8th Edition(2023) Florida Building Code

Proposed Code Modifications

FIRE

Total Mods for **Fire** in **Approved as Modified** : 4

Figure 601(2)
PROTECTION OF ROOF CONSTRUCTION

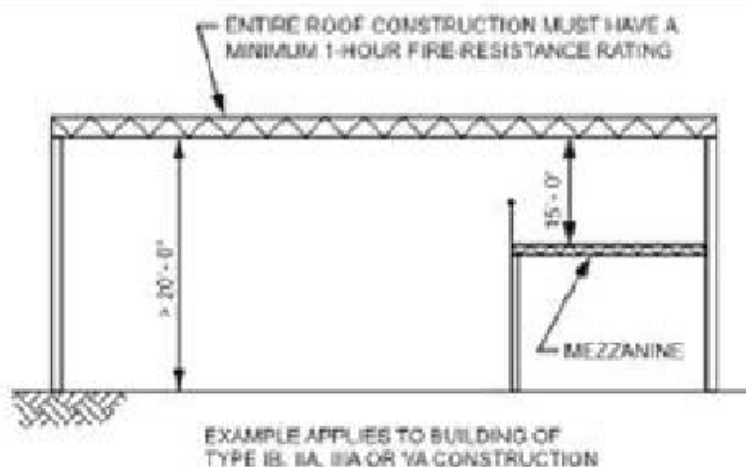
This proposal strengthens the code by eliminating a quirk allowing roofs in close proximity to mezzanines to be left unprotected.

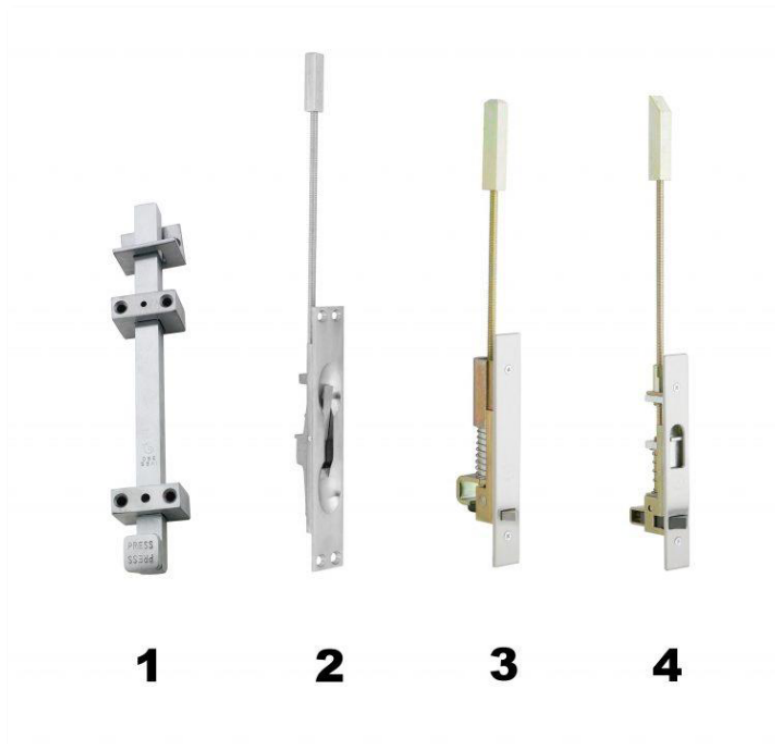
The revisions of Section 1010.1.9.4, Item 3, more accurately reflect the permitted uses of these door hardware items, and relies on the details in proposed Table 1010.1.9.4.

Section 1010.1.9.5 is deleted because:

1. The charging language not permitting manually operated flush bolts or surface bolts is moved to the charging language of 1010.1.9.6, and also revised per the proposed definitions.
2. Exception 1 of 1010.1.9.5 is incorporated into (revised) Exception 2 of 1010.1.9.6.
3. All the other exceptions of 1010.1.9.5 are incorporated into proposed Table 1010.1.9.4.

Several technical changes are incorporated in proposed Table 1010.1.9.4 that are not currently in these sections:
